TAX ID # 04372840
ON-SITE SEWAGE DISPOSAL SYSTEM
HOWARD COUNTY HEALTH DEPARTMENT
BUREAU OF ENVIRONMENTAL HEALTH

SUBDIVISION: Edgewood Farm LOT NUMBER: 55

WALLCHECK
LOT #55
EDGEWOOD FARM
LIBER 4174, FOLIO 0436
PLAT No. 19266, et seq
FOURTH ELECTION DISTRICT
HOWARD COUNTY, MARYLAND

TRENCH/DRAINFIELD DATA

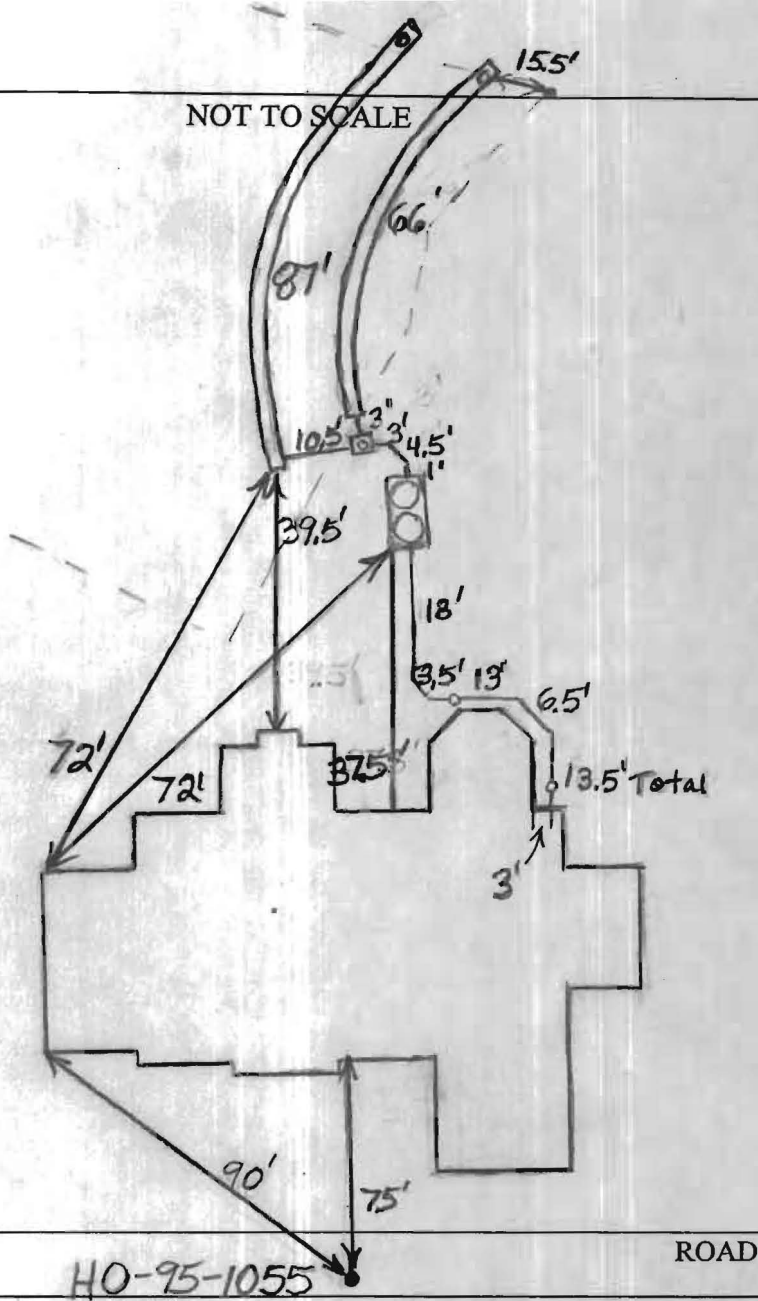
NUMBER OF BEDROOMS: 4 *Inlet 4' 3' Wide*
SQUARE FEET PER BEDROOM: _____ *Bottom 6.5'*

LINEAR FEET OF TRENCH REQUIRED: 140 150' *65'+85'*

PRE-CONSTRUCTION 9/10/08 I install a 65' and 85' trench on contour across the top of the easement. Keep tank close to easement. French specs. changed. (BB)

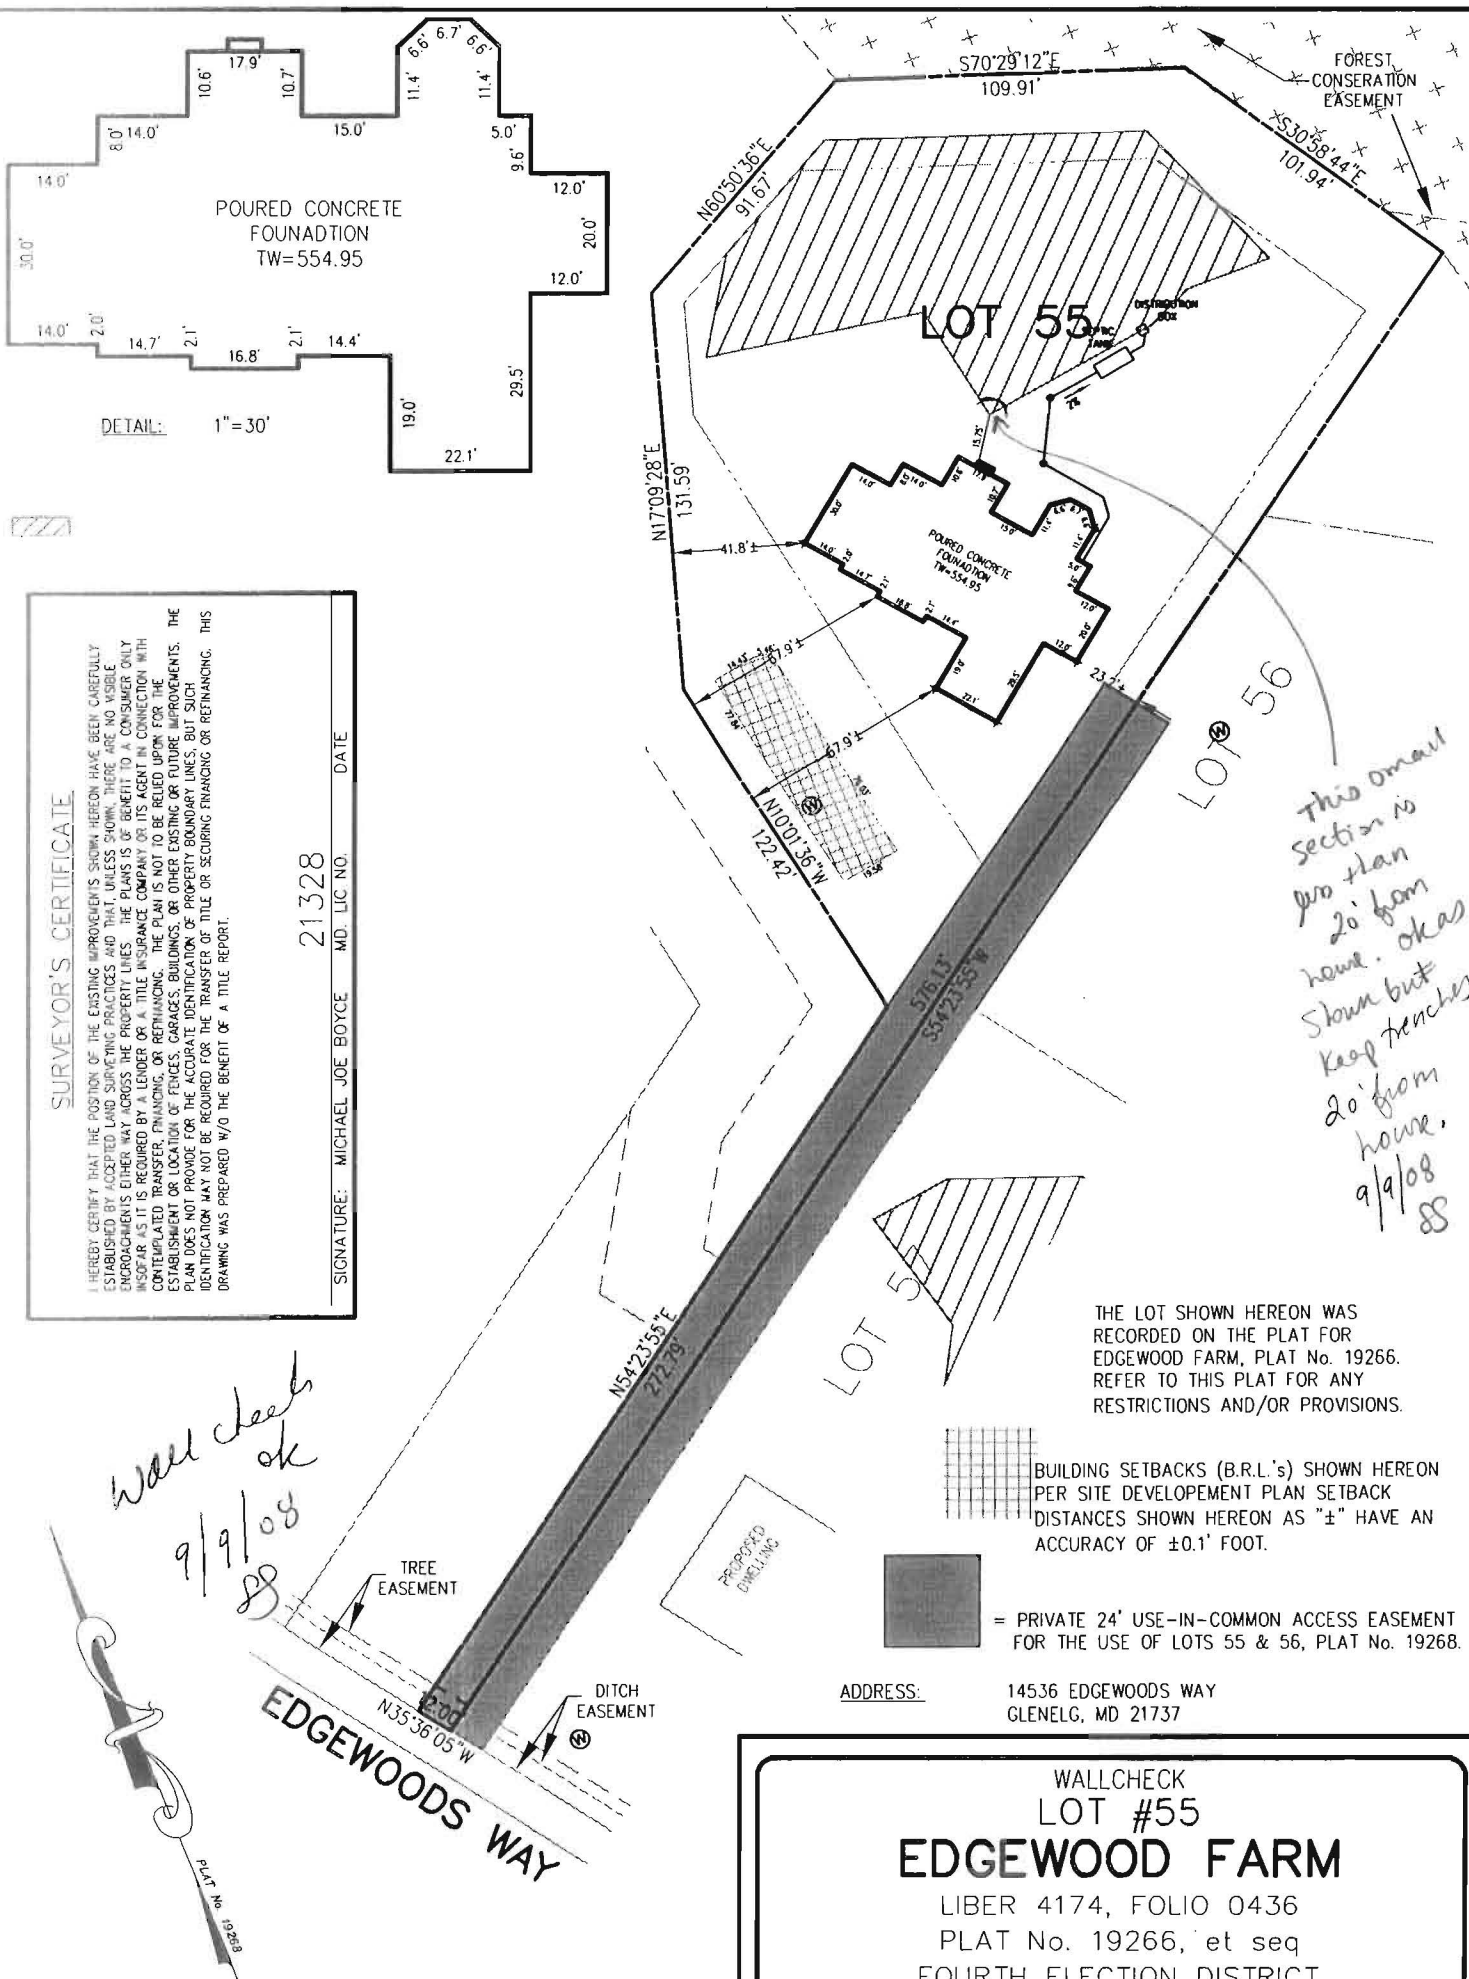
INSTALLATION 9/12/08 Need house connection. Home buyer didn't like tank location. Could interfere with a pool they plan to build. Dogles moved tank to location shown and added extra cleanout from house. O.K. to backfill. (BB)

This small section is 20' from house. ok as shown but keep trenches 20' from house. 9/9/08 SS

Wall checks ok 9/9/08 SS
